Access Compliance Report

Public Rights-of-Way

Intersection ID: 9428	Main Street: DOUBLE_OAKS_RD	Cross Street: EUREKA_ST	Location: NW
ADA ID: 7ECF7C53B574	Ramp Type: BlendTrans1	Initial Pass/Fail: Fail	Overall Compliance: No
		Severity Score: 25

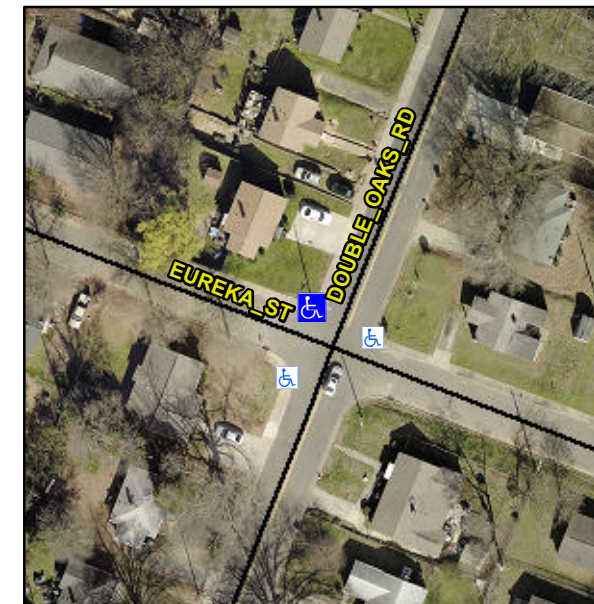
Not Found, R304.5.3

Compliance	Description	Data	Compliance	Description	Data
N/A	Ramp Length (in)	24.0	Yes	BlendTrans Slope (%)	2.1
Yes	Ramp Width (in)	59.0	No	BlendTrans XSlope (%)	10.9
N/A	Flare Type LT	N/A	N/A	Flare Type RT	N/A
N/A	Flare Slope LT (%)	N/A	N/A	Flare Slope RT (%)	N/A
N/A	Flare Traversable LT?	N/A	N/A	Flare Traversable RT?	N/A
N/A	Landing Length (in)	N/A	N/A	DWS Provided?	N/A
N/A	Landing Width (in)	N/A	N/A	DWS Contrast?	N/A
N/A	Landing Slope (%)	N/A	N/A	DWS Length (in)	N/A
N/A	Landing X Slope (%)	N/A	N/A	DWS Full Width?	N/A
N/A	Landing Curb? (Y/N)	N/A	N/A	DWS Offset (in)	N/A
N/A	Shared Landing?	N/A			
N/A	Gutter Ponding?	N/A	N/A	Gutter Slope (%)	N/A
N/A	Gutter Lip Ht (in)	0.5	N/A	Gutter X Slope (%)	N/A
N/A	Painted X Walk1?	No	N/A	Painted X Walk2?	No
	X Walk 1 Direction	To SW		X Walk 2 Direction	To E
	X Walk 1 Width (in)	N/A		X Walk 2 Width (in)	N/A
	X Walk 1 Slope (%)	11.5		X Walk 2 Slope (%)	5.9
	X Walk 1 X Slope (%)	2.5		X Walk 2 X Slope (%)	9.2

Remove & Replace Curb Ramp With Two New Directional Ramps or Equivalent.
